**HMC ARCHITECTS**  
**633 W. 5th Street, Third Floor**  
**Los Angeles, California 90071**

Oxnard College Dental Hygiene  
Ventura Community College District  
HMC # 5019001  
DSA # 03-114597

**ADDENDUM NO. 1**

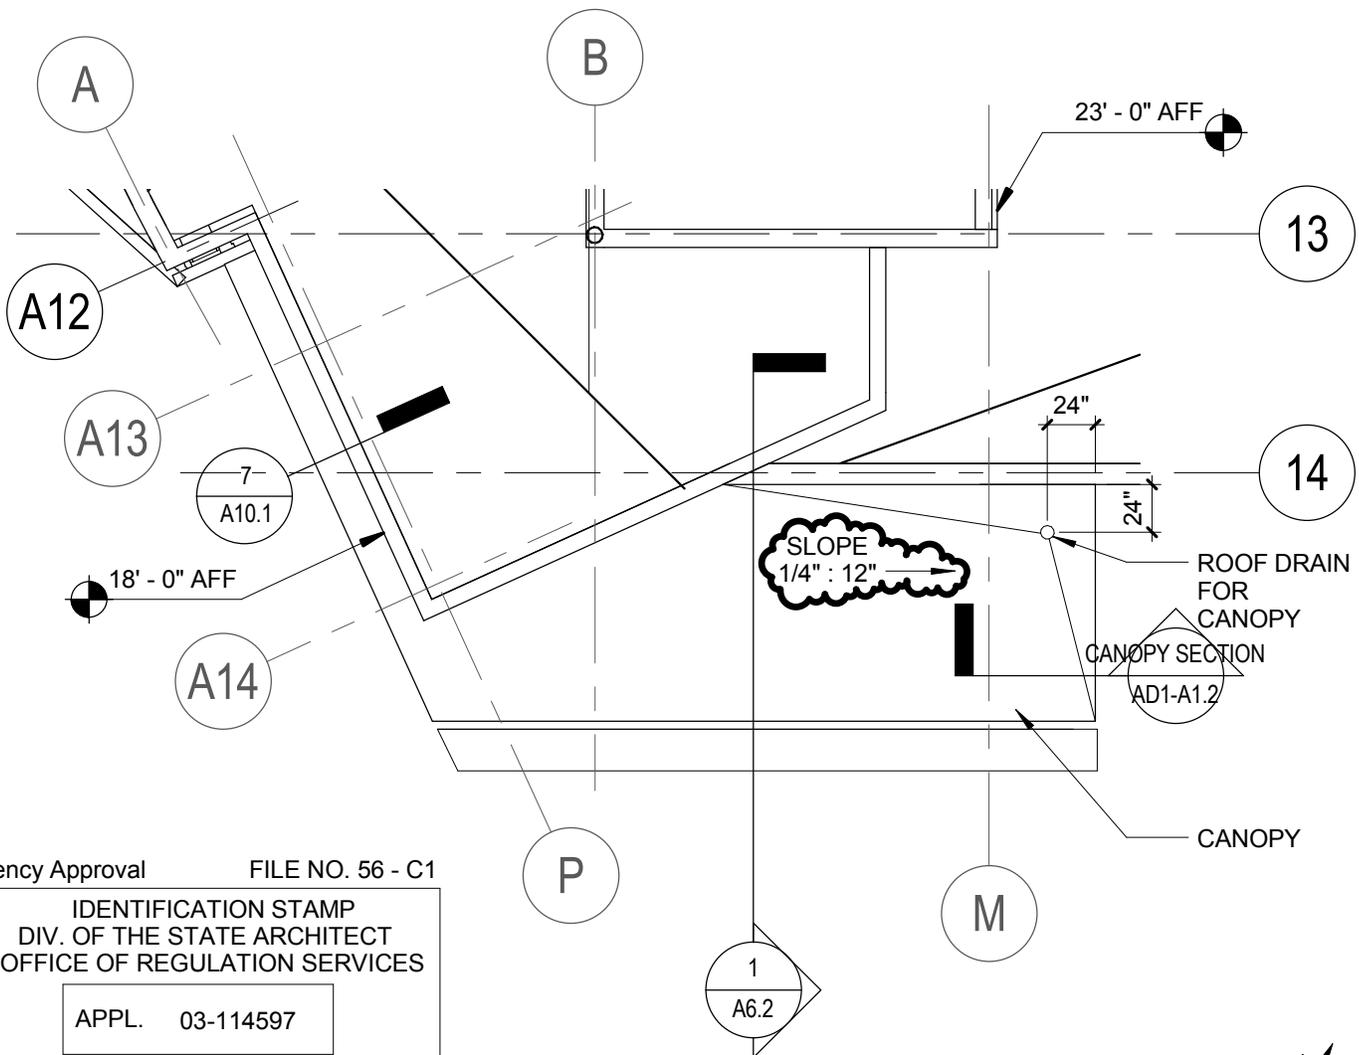
Item No. AD-1.29:                    Reference Drawing C4.20, Utility Details

- A. Revised detail D/C4.20, refer to attached detail AD1-C1.1.

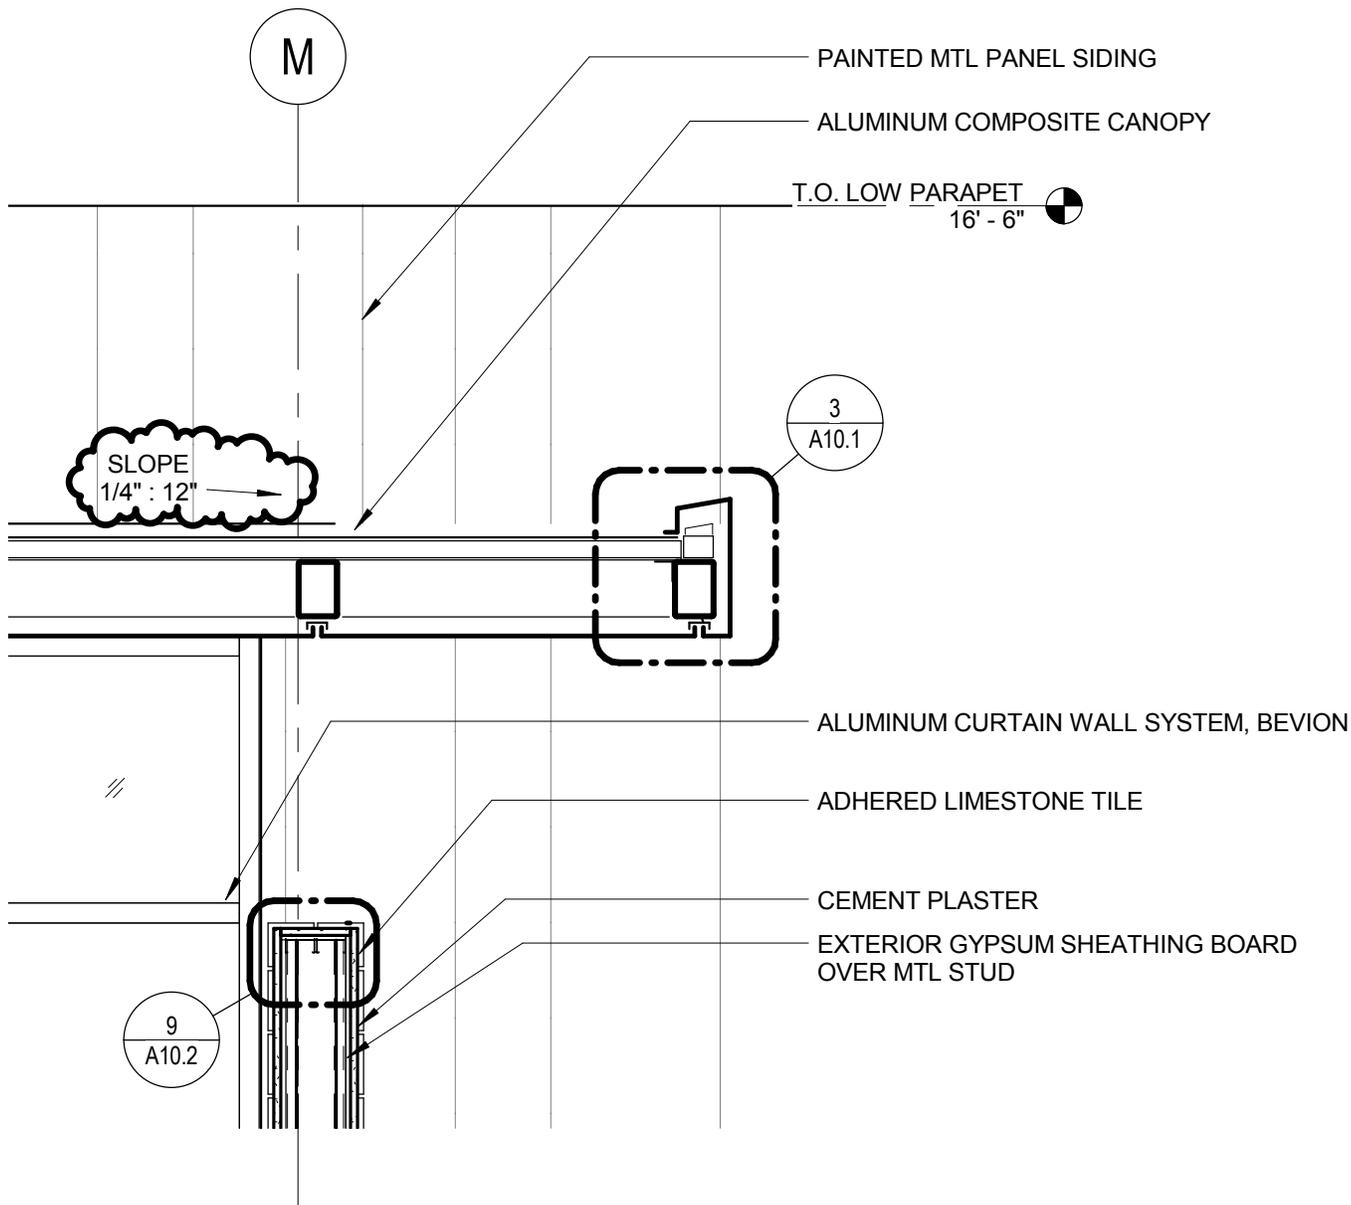
Item No. AD-1.35:                    Reference Drawing A4.1, Roof Plan

- A. Refer to AD1-A1.1 for slope at roof canopy.

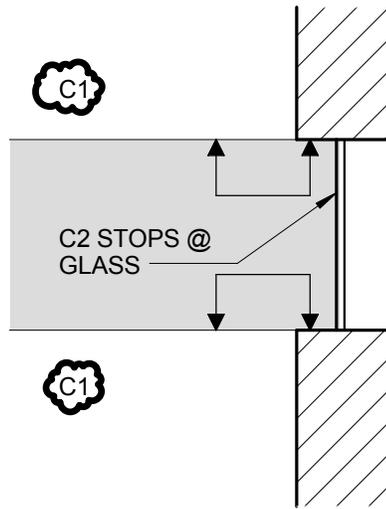
Item No. AD-1.50:                    Reference Drawing 2/A6.2, Plaza Partial Height Wall Section

- A. Refer to AD1-A1.2 for slope to roof canopy.

**Reference Drawing** 23/S-1.1 **Addendum #** 1

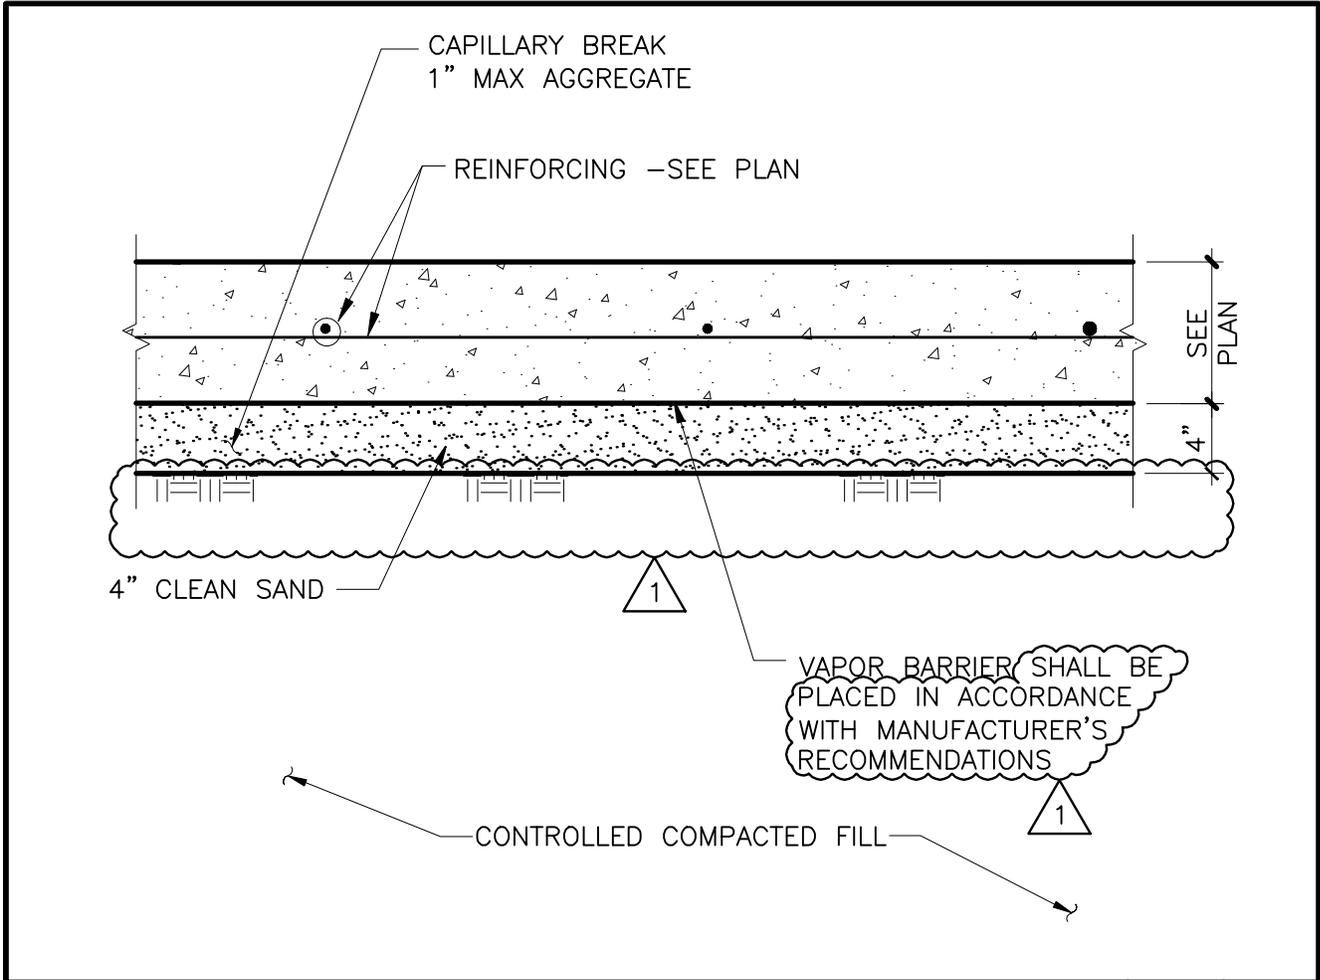
Item No. AD-1.55:

Reference Drawing 23/S1.1, Typical Slab Substrate

- A. Slab substrate reduced to 4" clean sand below slab on grade.
